Technical change to FieldPower® Power distribution box

PCN-number: PCN-PB40-20190604-00-A

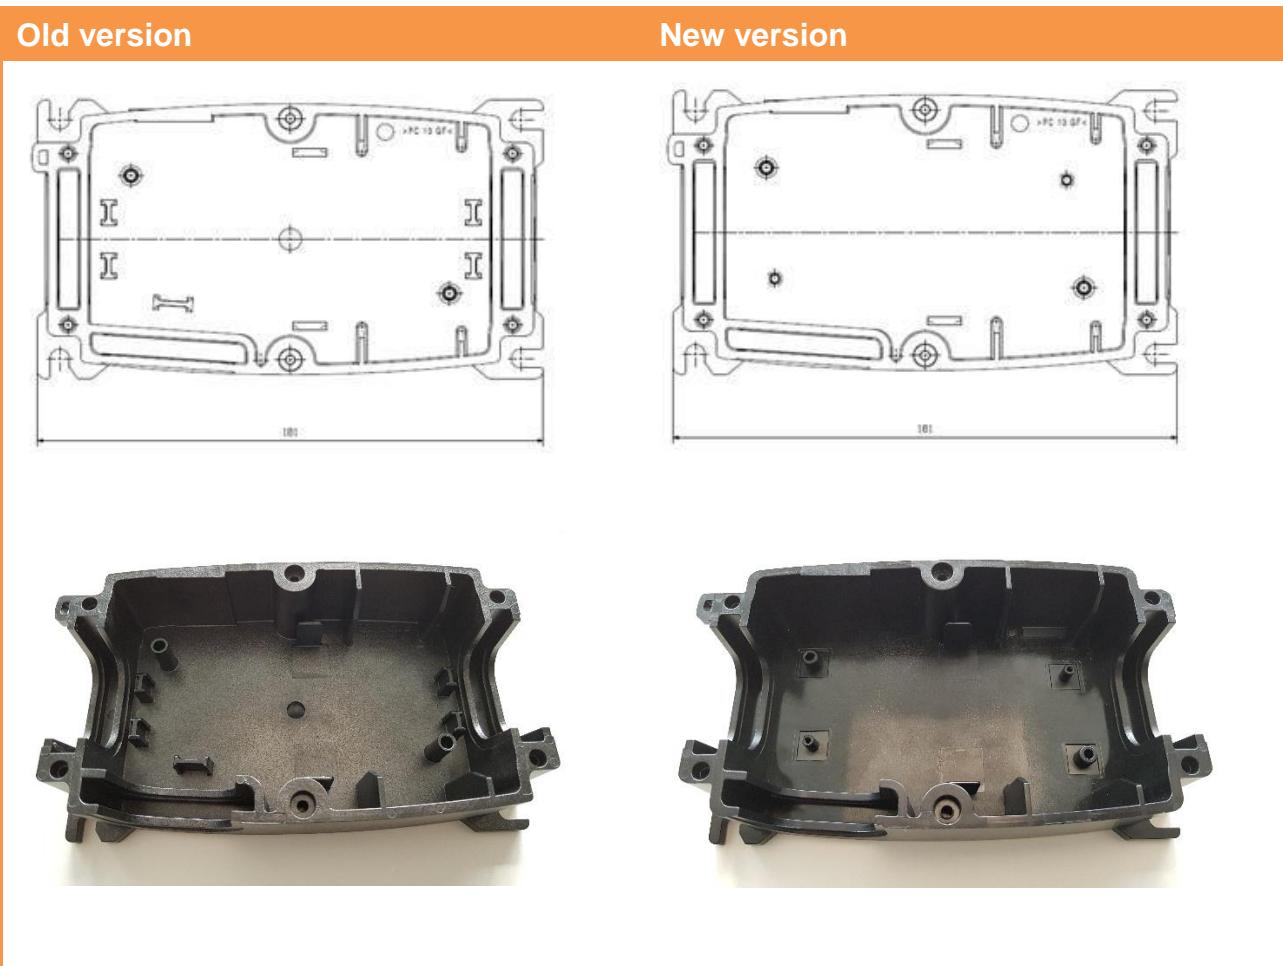
- The inner and outer shape of the enclosure base have been optimised. In the future, PCBs can thus be accommodated into the enclosure base in a simplified way.
- The colour scheme of the enclosure base has changed slightly. Visible glass fibre content is reduced.
